Access Compliance Report

Public Rights-of-Way

(Curb Ramps)

Intersection ID: 30467	Main Street: PLANTERS_ROW_DR	Cross Street: SPRING_FROST_CT	Location: SW
ADA ID: 30F0E2F8FF96	Ramp Type: PerpDiag	Initial Pass/Fail: Fail	Overall Compliance: No
Severity Score: 17.5			
Codes/Mitigation Info/Possible Solution		Field Measurements/Component Compliance

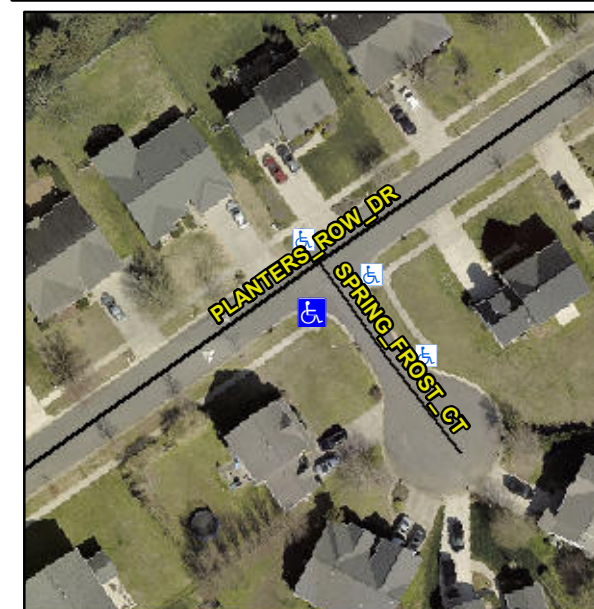
R304.5.1

Compliance	Description	Data	Compliance	Description	Data
N/A	Ramp Length (in)	69.0	Yes	Ramp Slope (%)	6.0
No	Ramp Width (in)	32.0	Yes	Ramp XSlope (%)	1.0
N/A	Flare Type LT	N/A	N/A	Flare Type RT	N/A
N/A	Flare Slope LT (%)	N/A	N/A	Flare Slope RT (%)	N/A
N/A	Flare Traversable LT?	N/A	N/A	Flare Traversable RT?	N/A
N/A	Landing Length (in)	N/A	N/A	DWS Provided?	N/A
N/A	Landing Width (in)	N/A	N/A	DWS Contrast?	N/A
N/A	Landing Slope (%)	N/A	N/A	DWS Length (in)	N/A
N/A	Landing X Slope (%)	N/A	N/A	DWS Full Width?	N/A
N/A	Landing Curb? (Y/N)	N/A	N/A	DWS Offset (in)	N/A
N/A	Shared Landing?	N/A			
N/A	Gutter Ponding?	N/A	N/A	Gutter Slope (%)	N/A
N/A	Gutter Lip Ht (in)	N/A	N/A	Gutter X Slope (%)	N/A
N/A	Painted X Walk1?	No	N/A	Painted X Walk2?	No
	X Walk 1 Direction	To NE		X Walk 2 Direction	To NW
N/A	X Walk 1 Width (in)	N/A	N/A	X Walk 2 Width (in)	N/A
	X Walk 1 Slope (%)	2.5		X Walk 2 Slope (%)	0.0
	X Walk 1 X Slope (%)	1.5		X Walk 2 X Slope (%)	2.0

Remove & Replace Curb Ramp With Two New Directional Ramps or Equivalent.
